TR-7625

#826

SUBJECT: TR-7625 HYBIRD AMPLIFIER MODULE SUBSTITUTION

DATE 5/30/80

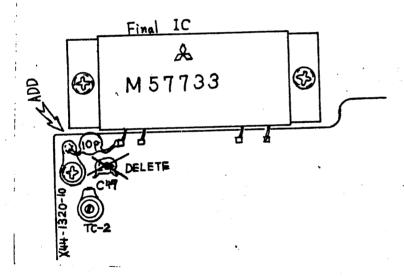
1. Remove and delete C49, 22pF.

Add a ground lug adjacent to the RFI terminal.
Add 10pF across the RFI terminal and ground.

1. Adjust TC2 for maximum output at 146MHz.

2. Adjust VR4 for 5W output at 146MHz, low power.

New Part: 10pf C45CH100D
